SOUTH BATTERY PARK CITY RESILIENCY

CB1 UPDATE

MARCH 21, 2022

PDC FEEDBACK - EXPOSED FLOODWALL SUBMISSION | SEPT 2021

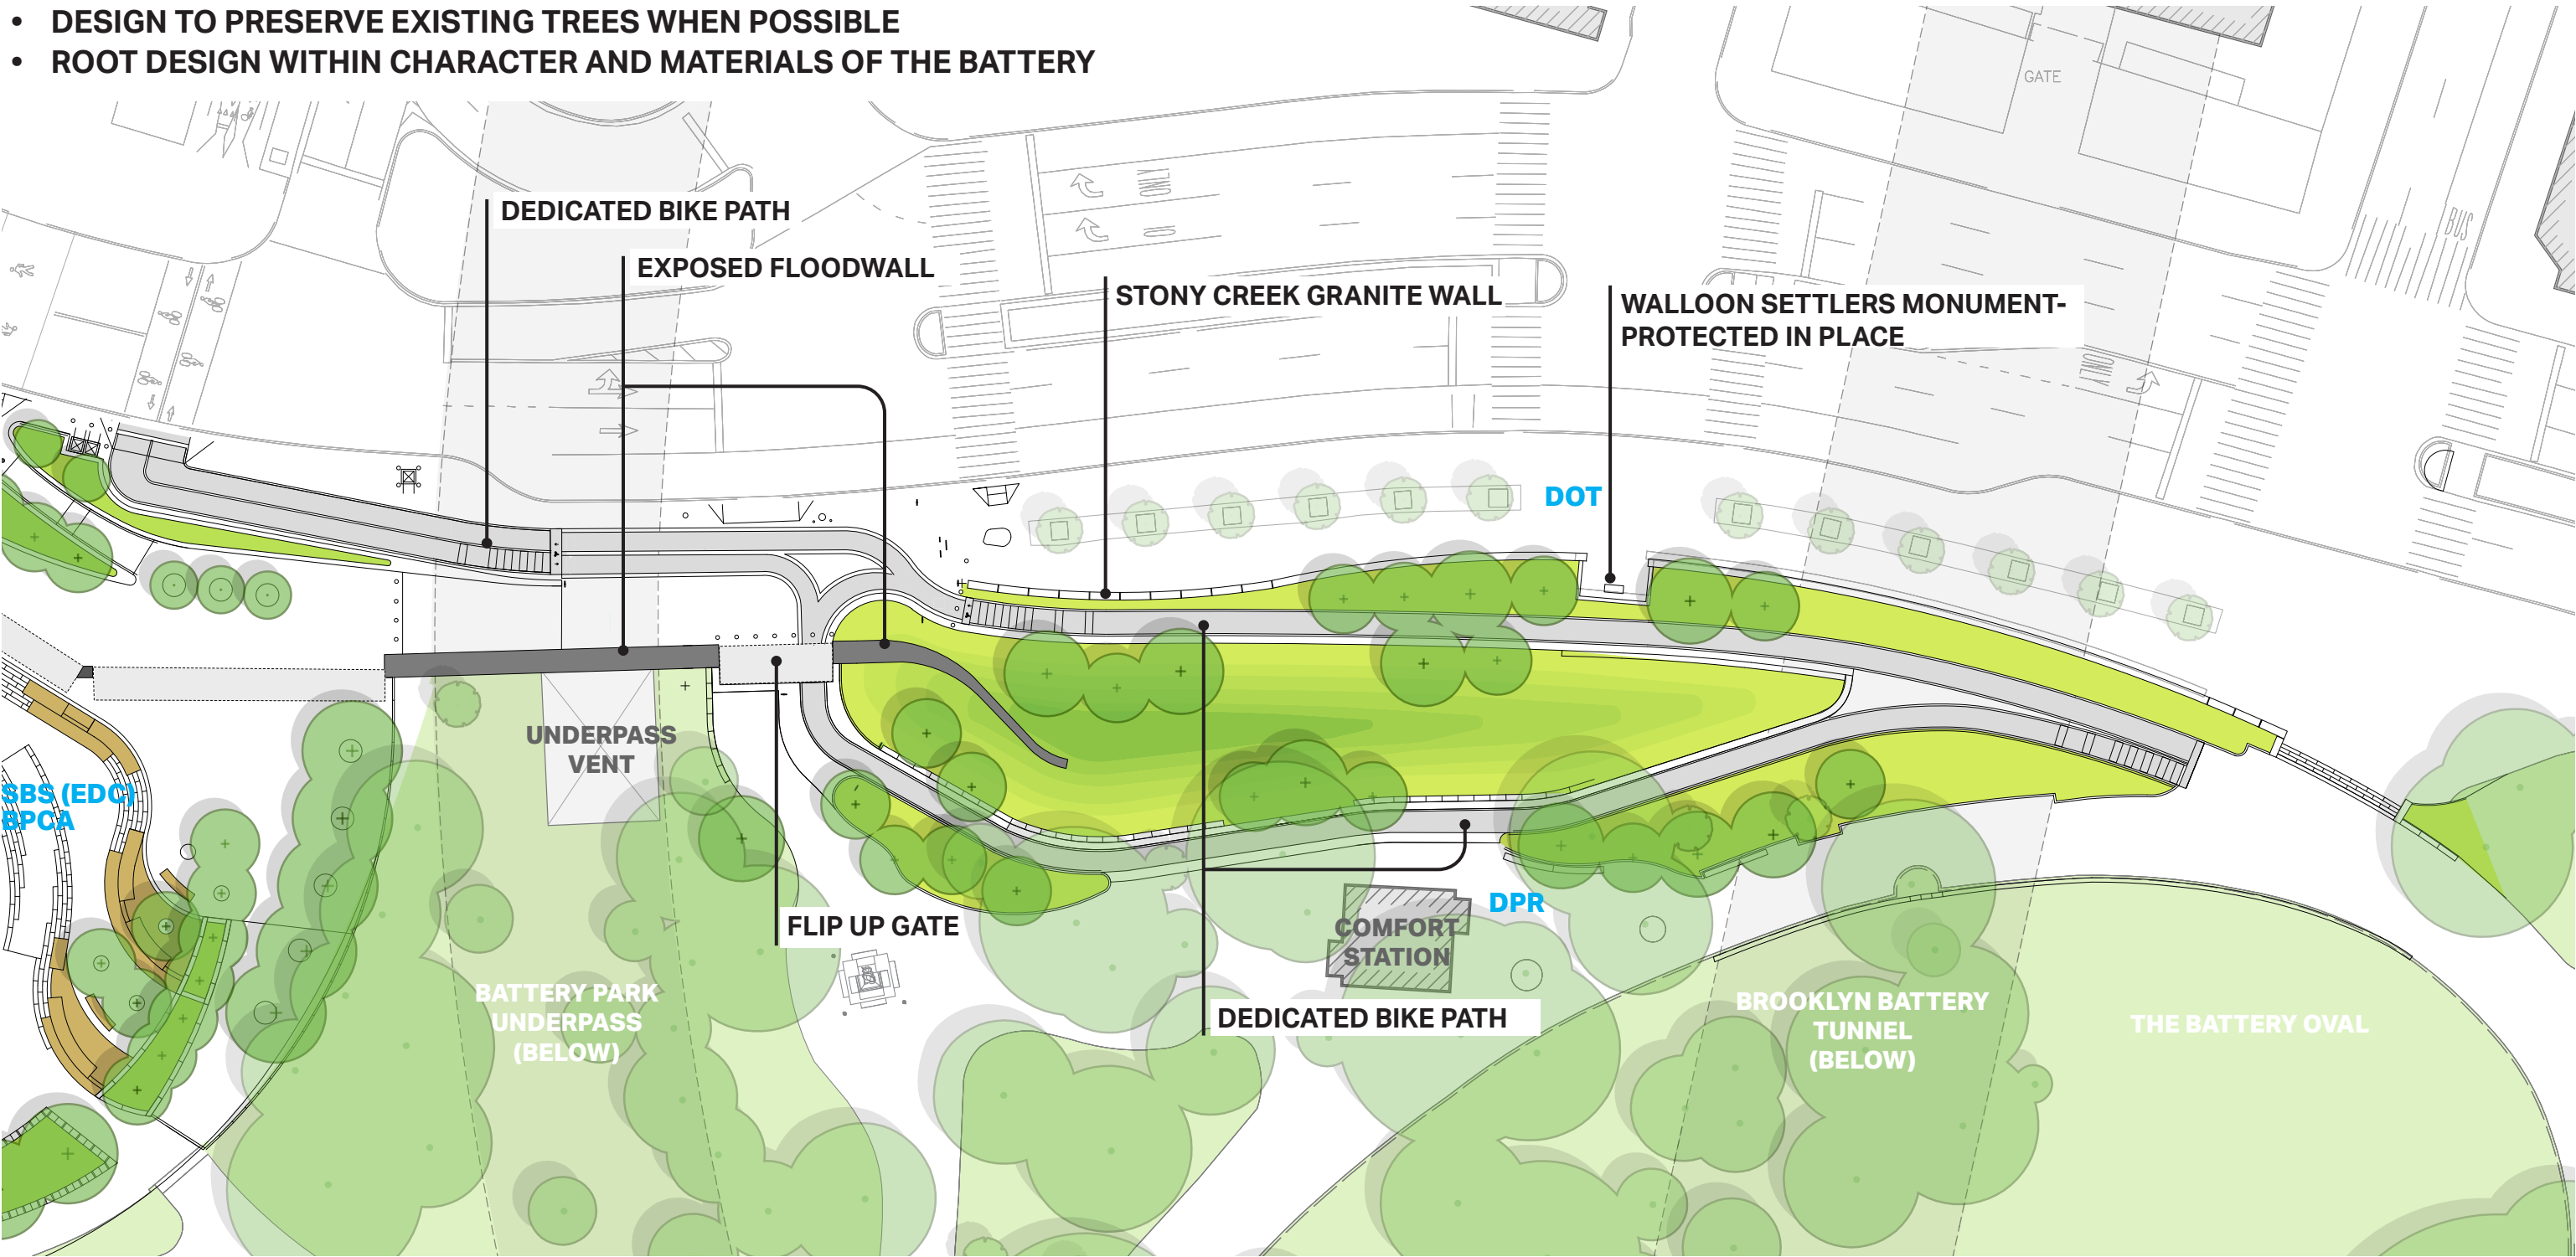
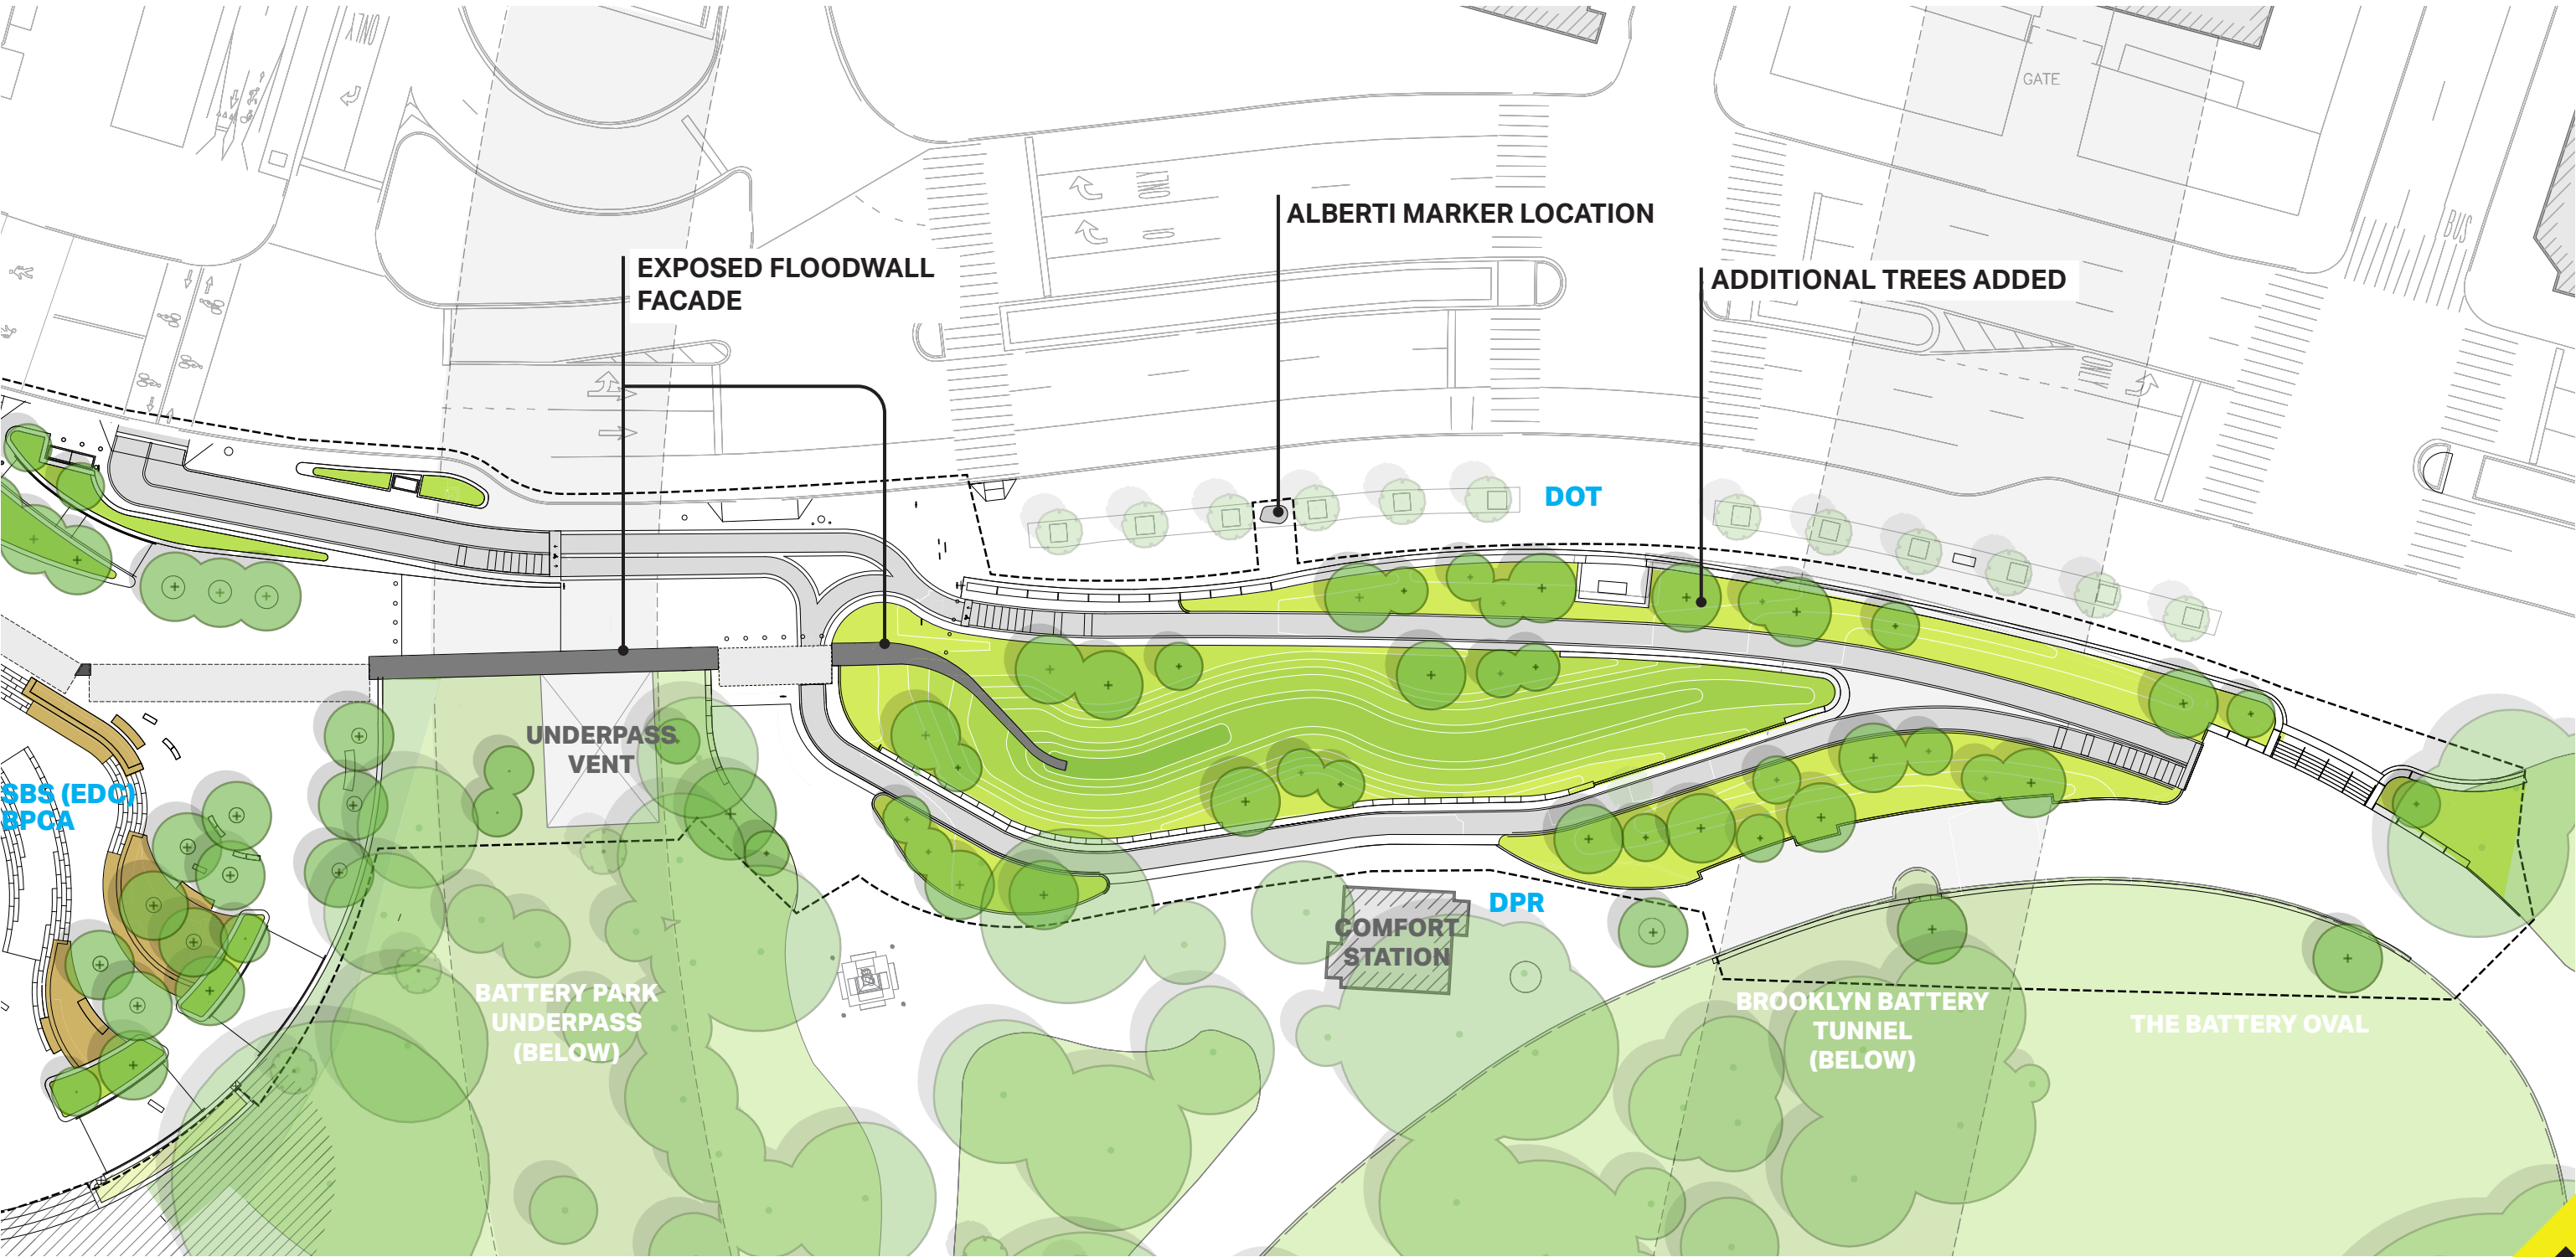
- Expressed that the “abstract expressions” of land and water are not legible as the utilization of two different stones reinforces the decorative nature of the stone-facing rather than acknowledging, celebrating, and creating a cohesive language across the infrastructure

- Requested that the Stony Creek be removed from the stone facing so that the wall is expressed with only the Pearl Gray stone
 - Will allow the existing Stony Creek on-site to be more visually prominent in the pedestrian foreground

- Designing the wall in the singular stone palette will celebrate both the material of the cladding and the function of the wall
- Revise coping design so that the schist reference is applied across the full stretch of the wall and detailing be studied to remove threat of water infiltration

- Requested a scale model to help understand the visual impact of the stone module sizes proposed, how they are legible across the wall
